**TOWN OF WINTER PARK
PLANNING COMMISSION
Tuesday, April 26, 2022 8:00 AM**

TO Planning Commission
FROM Hugh Bell, Planner
THROUGH James Shockey, Community Development Director
DATE April 26, 2022
RE Single-Family Detached Design Review – Lot 12A, Whiting Tracts – 499 Kings Crossing Road (PLN21-126)

TO Planning Commission
FROM Hugh Bell, Planner
THROUGH James Shockey, Community Development Director
DATE April 26, 2022
RE Amendment to Design Review Single-Family Attached – Lots 9-18, Block 5, Roam Subdivision Exemption No. 3 – 13-49 Ski Idlewild Road (PLN20-045)

PERMIT DRAWINGS
ELEVATIONS
A-4
3/21/2022

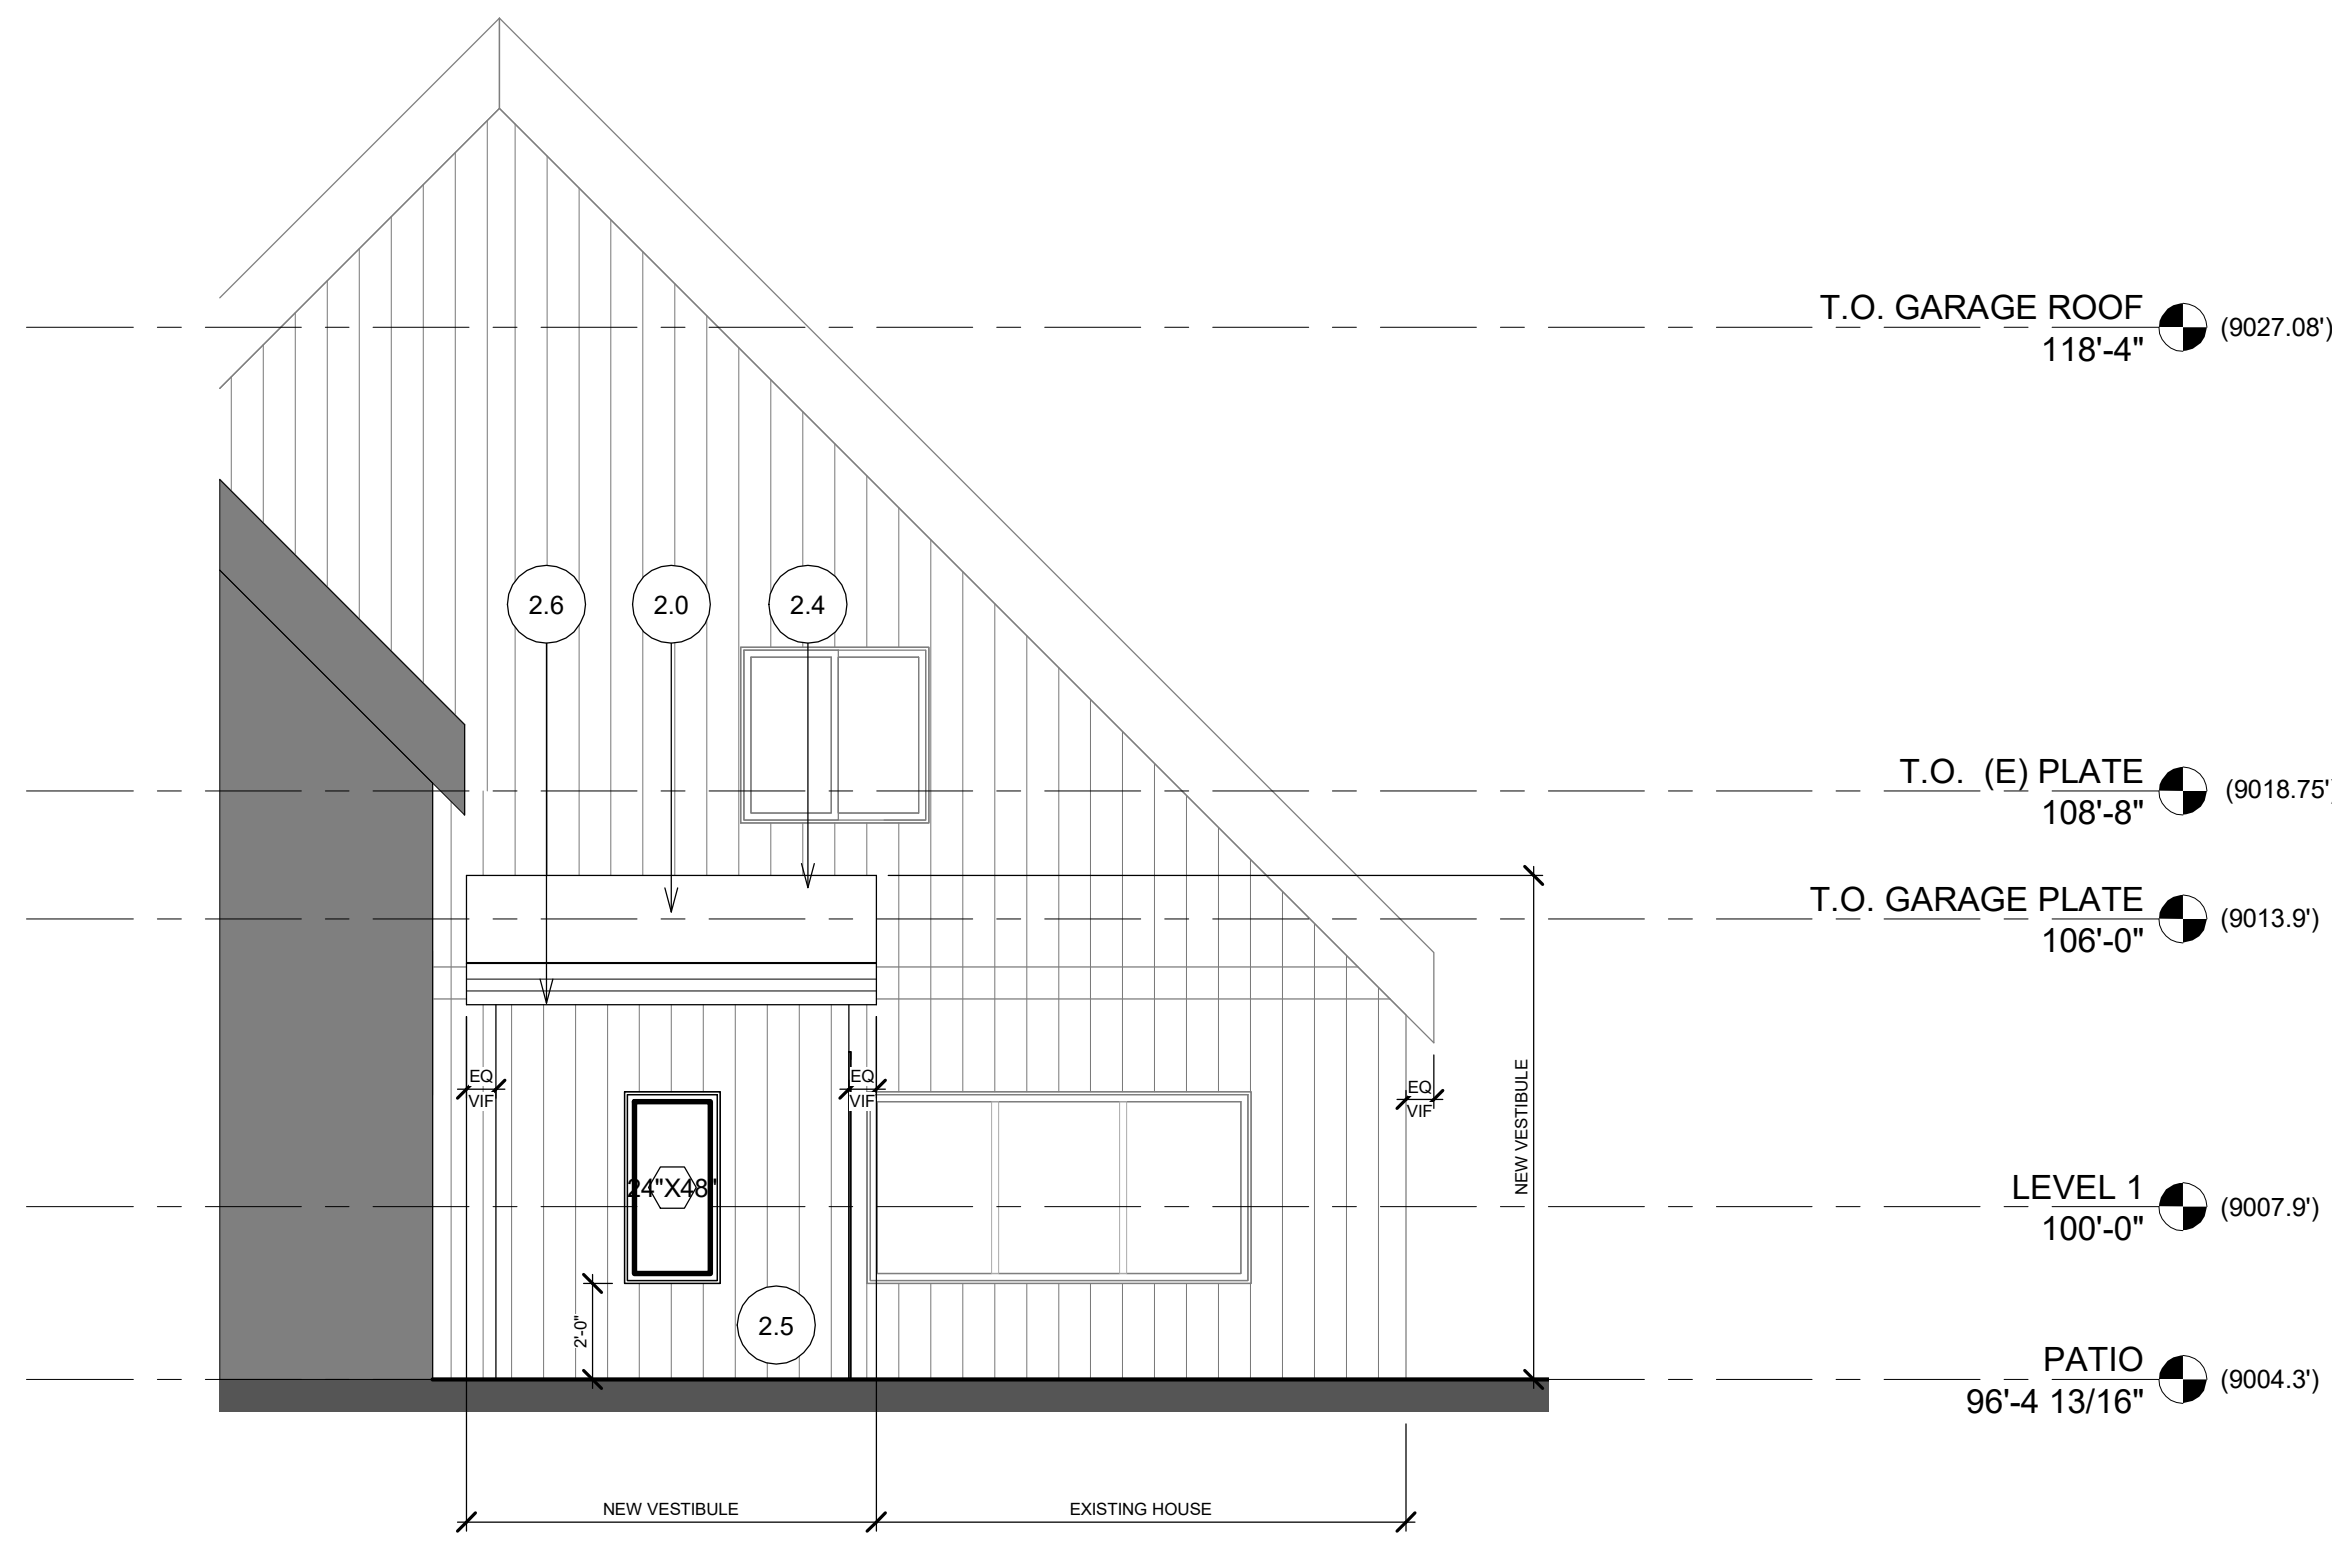
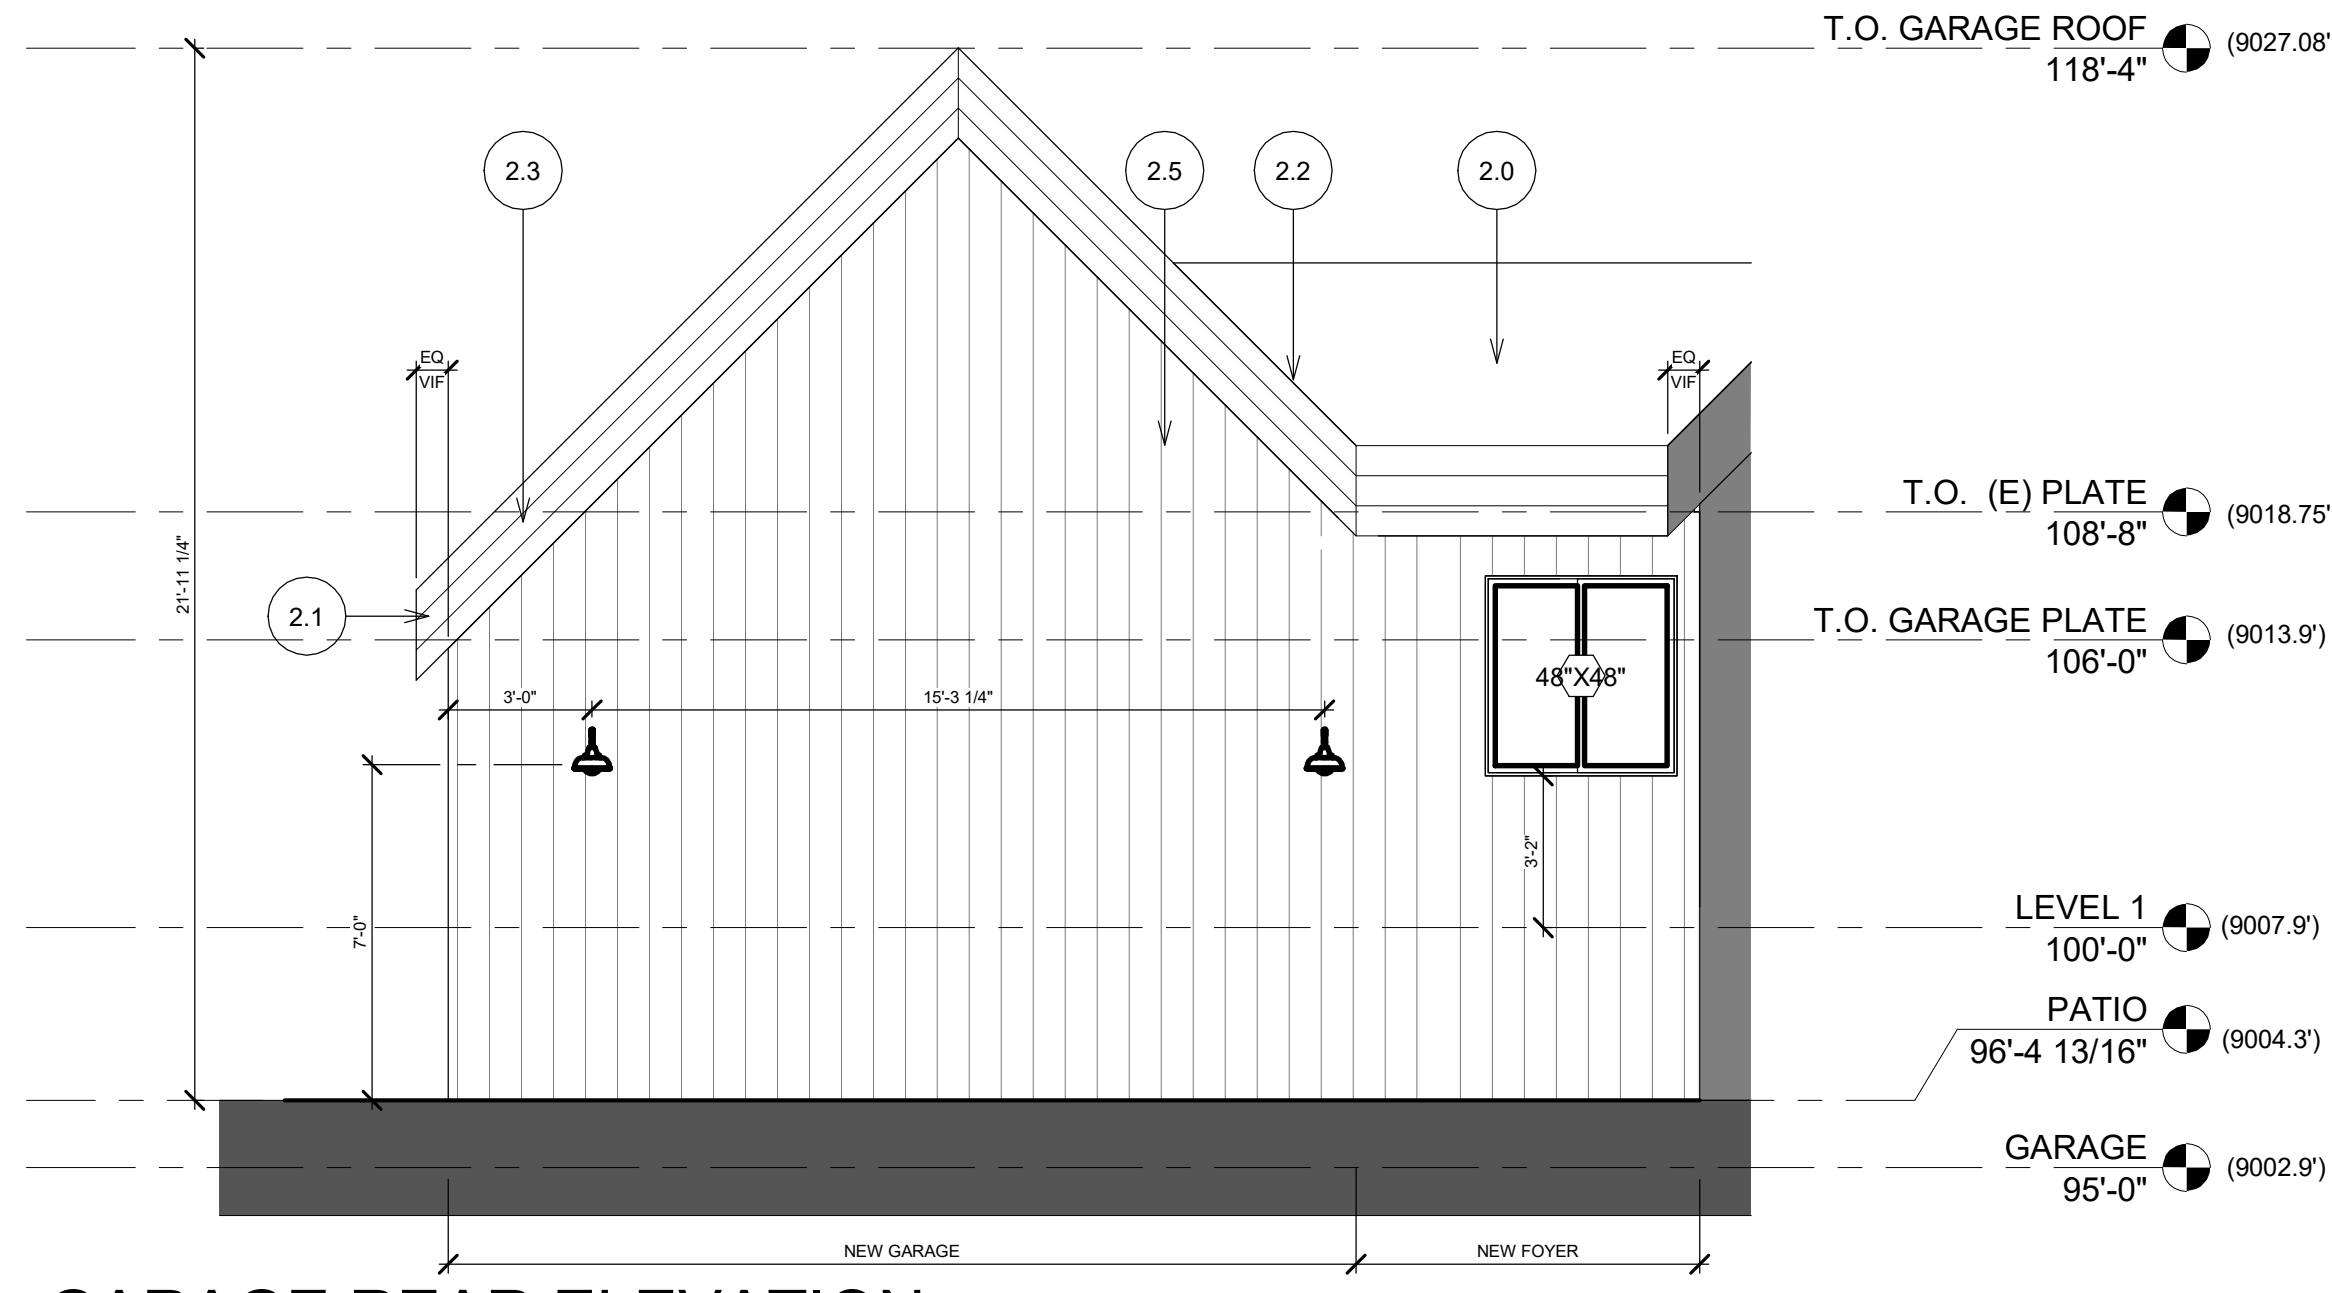
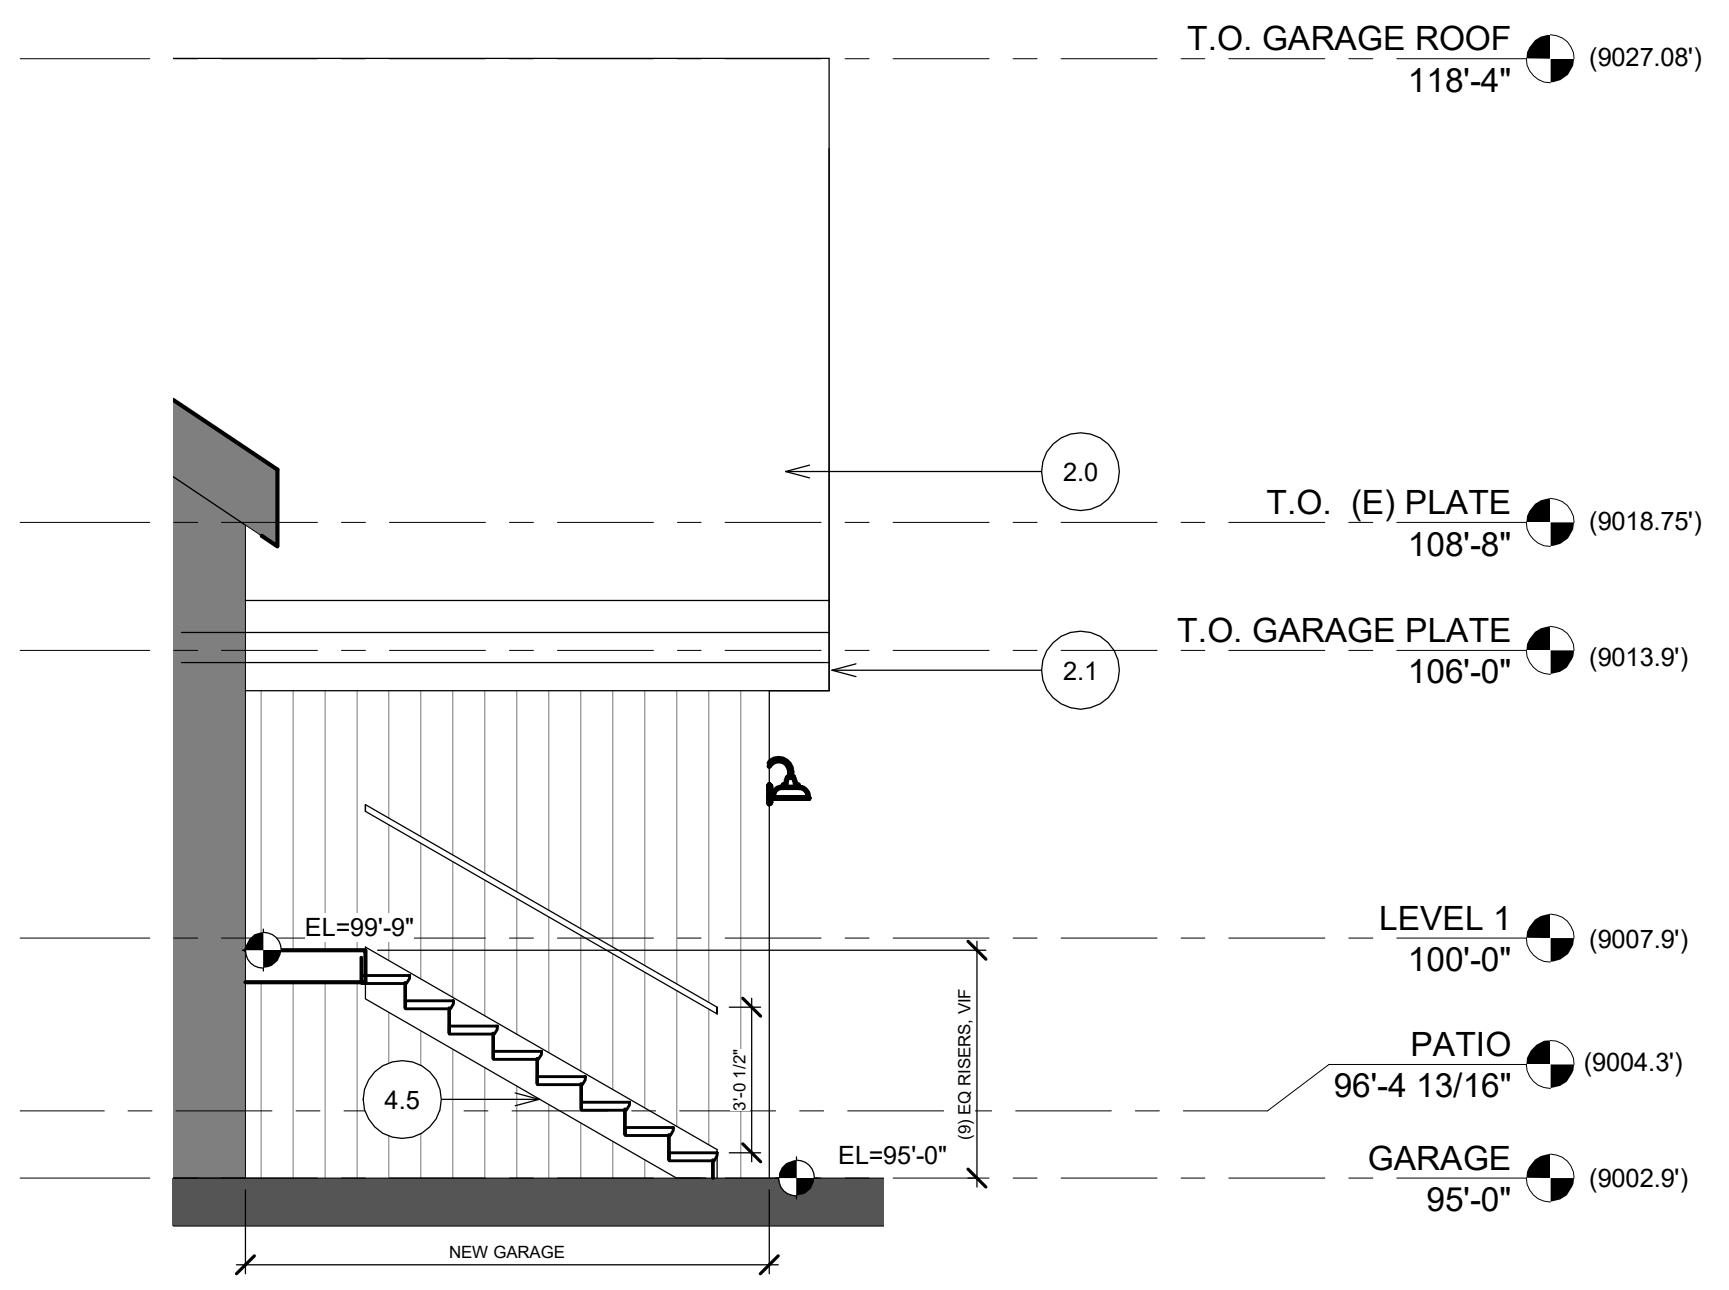
Unsatisfactory. Only proposed grade is depicted on elevation drawings. It appears the building is well under the maximum permitted midpoint building height of 35' but revised elevations will be necessary for staff to confirm.
